Access Compliance Report Public Rights-of-Way (Curb Ramps)

Main Street: CHANNING_WAY Cross Street: FOSTER_RD Location: SE

ADA ID: RPAT211206115228 Ramp Type: Type 1 - Perpendicular Diagonal Initial Pass/Fail: Pass Overall Compliance: No Severity Score: 4

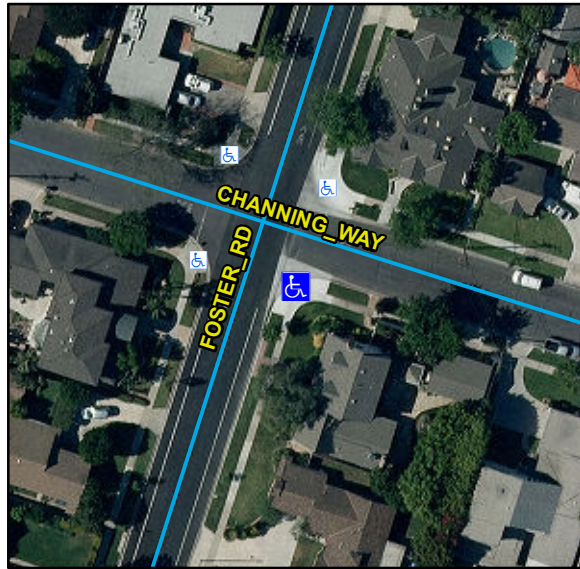
Remove & Replace Landing.
